**Lot: 142****Model: 40.02 A VALLEYVIEW****Project/Phase: Pine Valley Forevergreen / 1**

CONSTRUCTION SUMMARY

SCHEDULE 'F'

The Valleyview

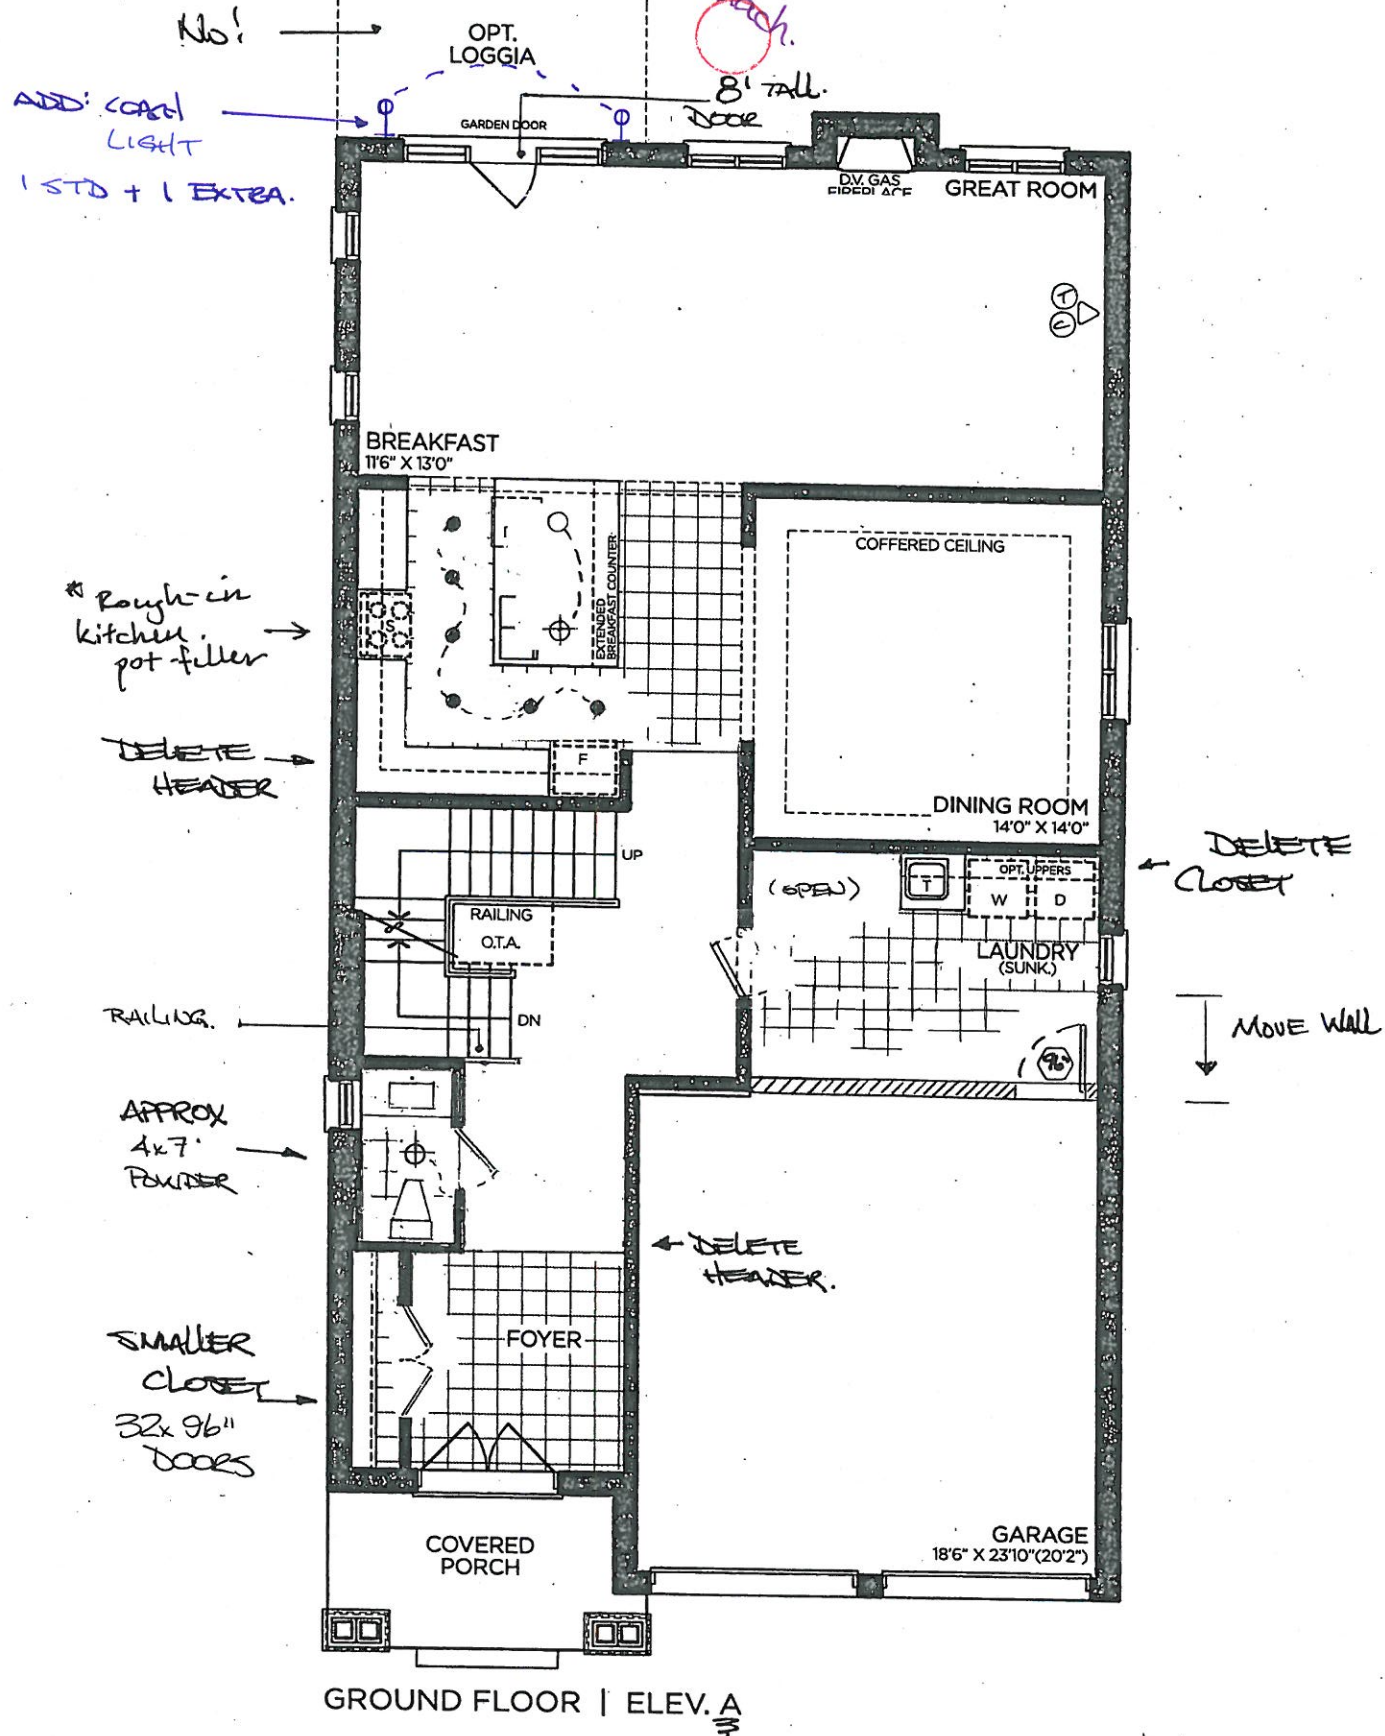
Invoice	Qty.	Description
2267	1	***REVISED LAYOUT*** MOVE REAR GARAGE WALL APPROX 3' (SQUARE OFF REAR OF GARAGE) TO CREATE LARGER LAUNDRY ROOM. MOVE DOOR FROM GARAGE TO HOUSE CLOSER TO EXTERIOR WALL. SEE PLAN FOR LOCATION. [COMPLETE WITH STANDARD LEVEL FINISHES]
07Aug20 NoCat

Invoice	Qty.	Description
2347 07Aug20 NoCat	1	.**CUSTOM LAYOUT** REVISE LAYOUT OF POWDER ROOM. INTERIOR OF POWDER ROOM TO BE APPROX. 4'X7'. REDUCE FOYER CLOSET TO ACCOMMODATE, INSTALL LARGER CLOSET DOORS - SEE ATTACHED SKETCH
2347 07Aug20 NoCat	1	.INCREASED HEIGHT TO MAN DOOR FROM HOUSE TO GARAGE (32X94") TALL HEIGHT - IF GRADE PERMITS (EACH)
2347 07Aug20 NoCat	1	***CUSTOM LAYOUT** DELETE CLOSET AT LAUNDRY
2347 07Aug20 NoCat	1	.**CUSTOM LAYOUT** ENSUITE 3/4: REMOVE WALL AND DOOR SEPARATING VANITY/WATER CLOSET - LEAVE 1 OPEN SPACE
2347 07Aug20 NoCat	1	.**CUSTOM LAYOUT** REMOVE HEADER AND NIB WALL AT FOYER/MAIN HALL & MAIN HALL/KITCHEN
2347 07Aug20 NoCat	1	.**CUSTOM LAYOUT** REMOVE DOUBLE DOORS AT MASTER BEDROOM, INSTALL SINGLE LARGER DOOR - MOVE TOWARD FRONT OF HOUSE. REMOVE DOOR TO WIC, CREATE APPROX 42" OPENING - NO HEADER OR NIBB WALLS AT WIC - SEE PLAN FOR LOCATION
2347 07Aug20 NoCat	1	.**NOTE** INSTALL 32" X 96" DOOR FROM LAUNDRY TO HALLWAY

SECOND FLOOR | ELEV. A

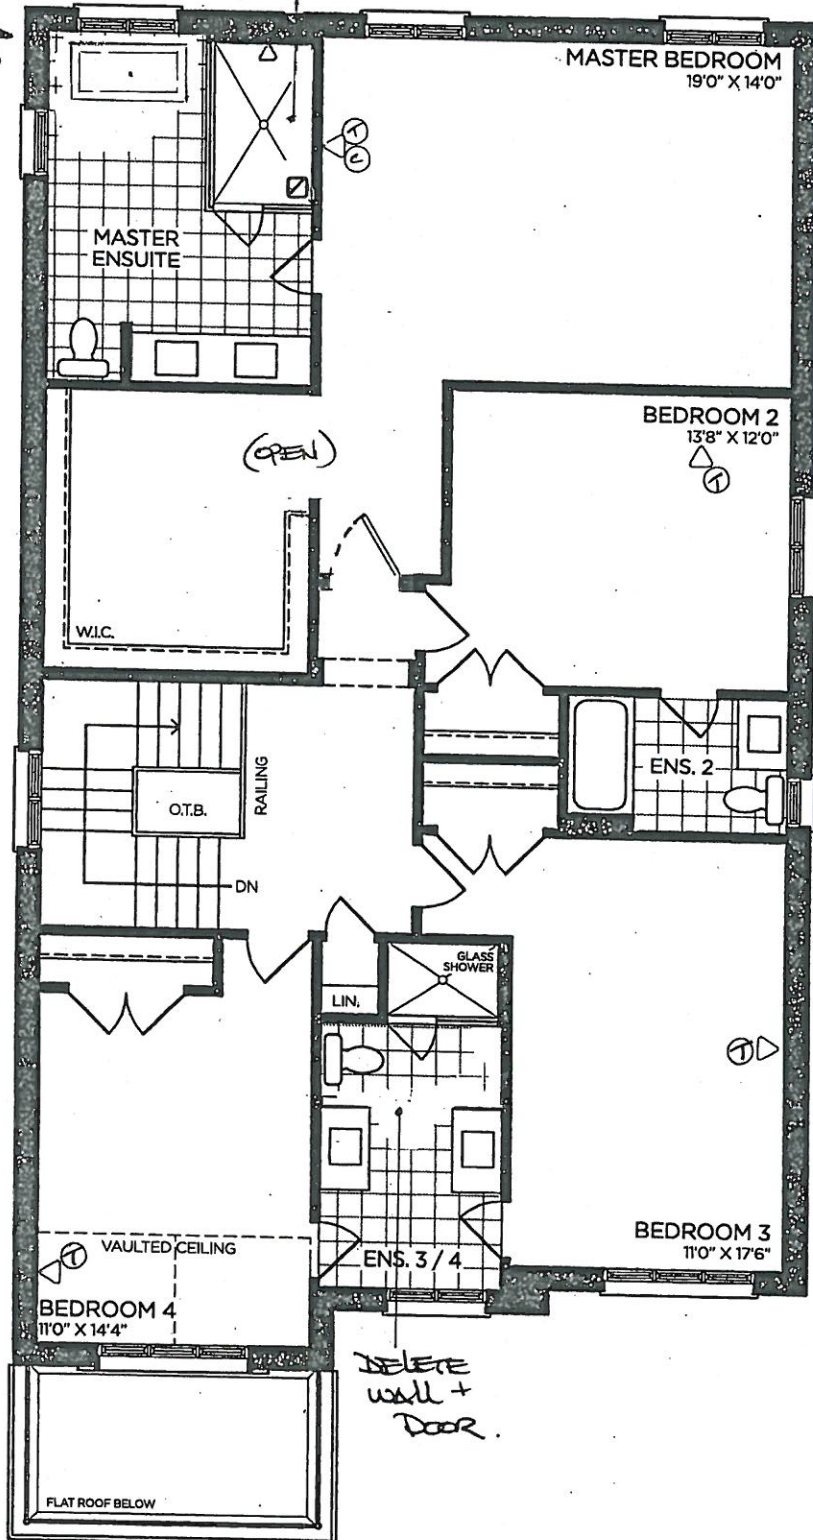
RANSHUR + shower niche

CENTER TUB BELOW window

W.I.C. → 42" OPENING
(NO HEADER)
(MOVE)
1 LARGER DOOR
to KIDRM. →

BASEMENT | ELEV. A

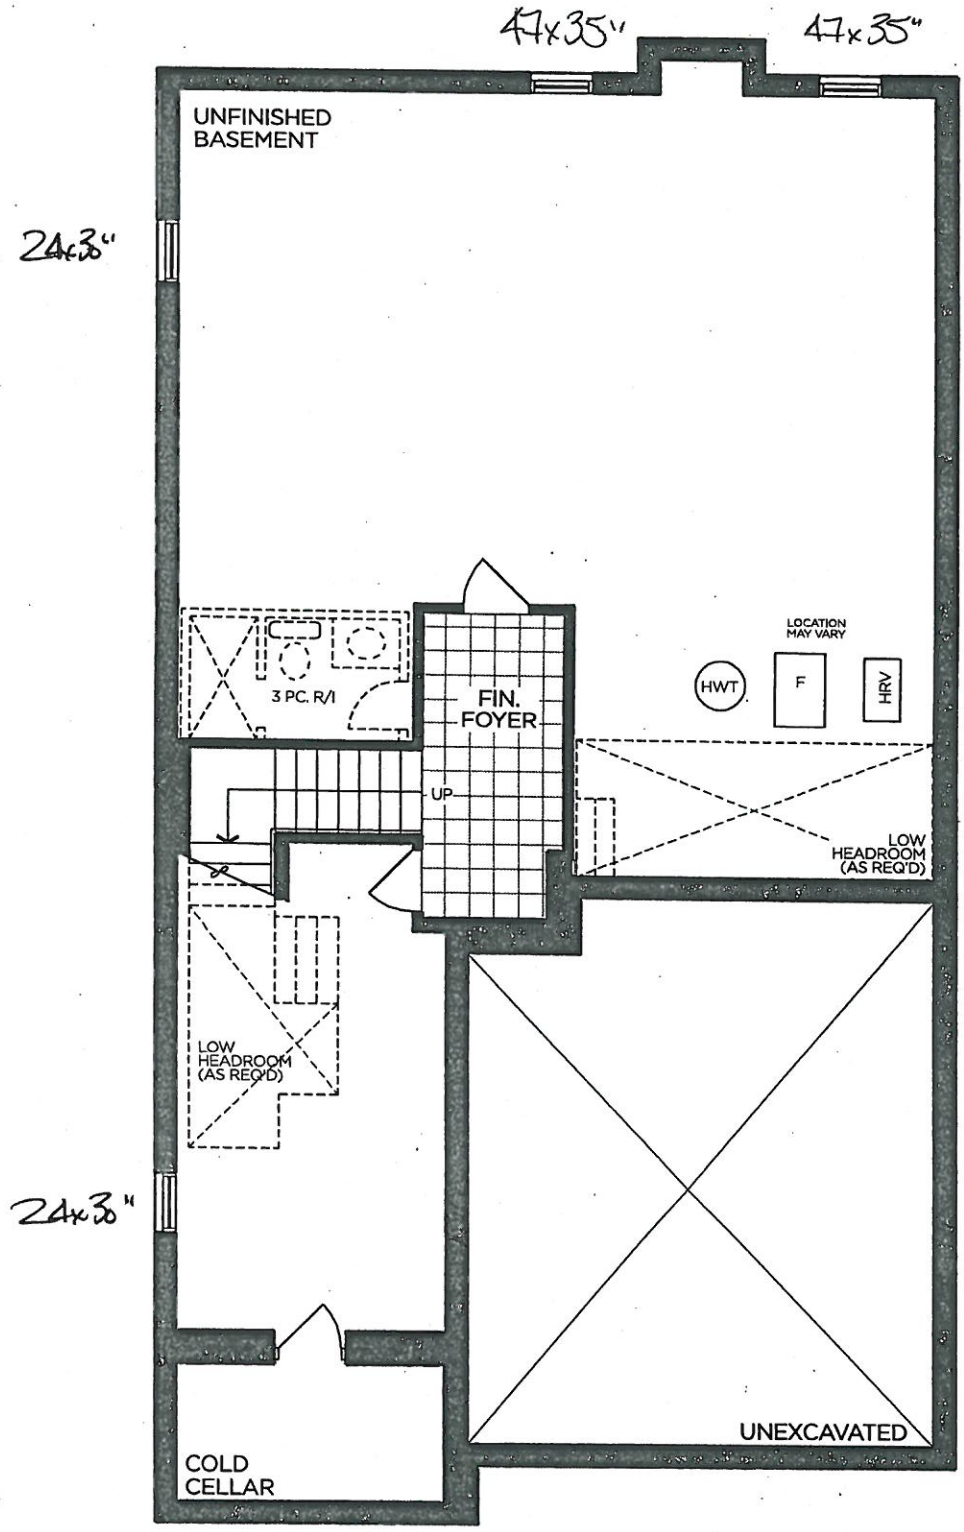
WINDOWS - BASEMENT		
Invoice	Qty.	Description
2267 72,351 07Aug20	2	.BASEMENT WINDOWS - UPGRADE BASEMENT WINDOW SIZE TO 30 " X 24" - 8" FRAME
2305 72,672 07Aug20	2	.BASEMENT WINDOWS - EGRESS BASEMENT WINDOW 47 " X 35" - 8" FRAME- REAR ONLY REAR ONLY

SECOND FLOOR | ELEV. A

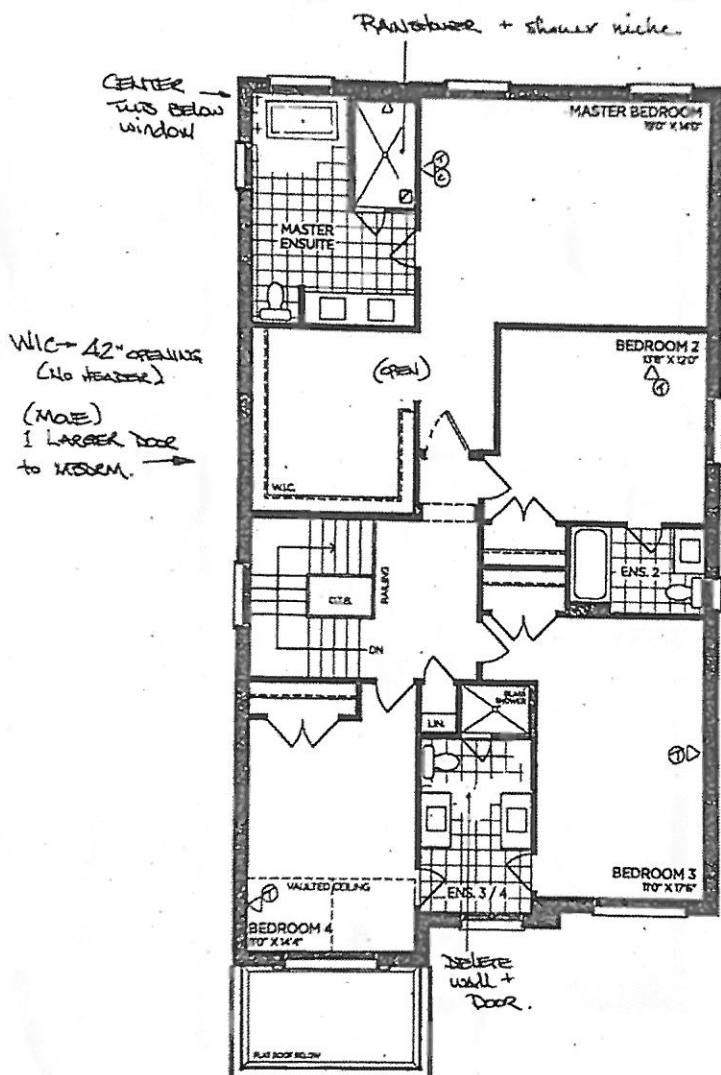
PLUMBING FIXTURES		
Invoice	Qty.	Description
2347 07Aug20 NoCat	1	.MASTER ENSUITE: UPGRADE TO MOEN 90* RAIN SHOWER (from ceiling) + HAND SHOWER WITH SLIDE BAR `CHROME` #TS2712EP/3372/TS4172/62320/S3879EP/A721
2347 07Aug20 NoCat	1	.MASTER ENSUITE: REPOSITION TUB TO BE CENTERED BELOW REAR WINDOW - SEE PLAN FOR LOCATION

BASEMENT | ELEV. A

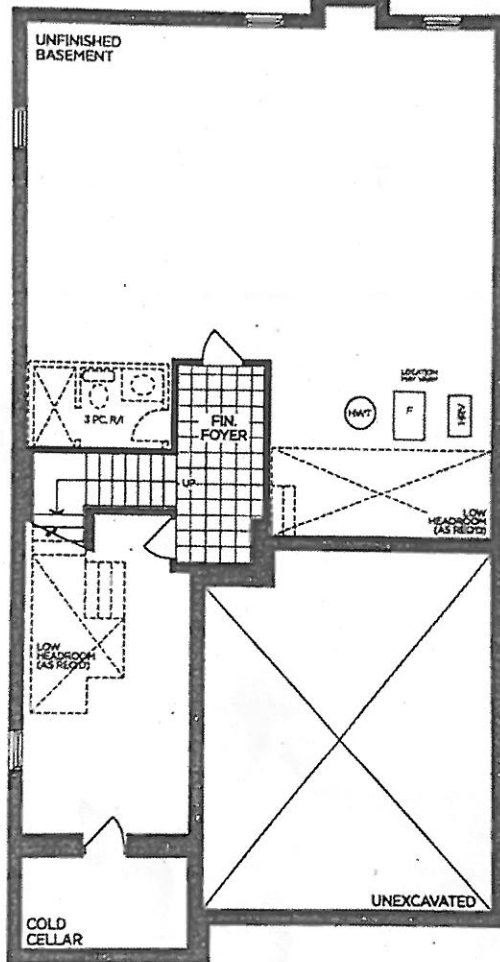
47x35"

47x35"

24x3"

24x3"
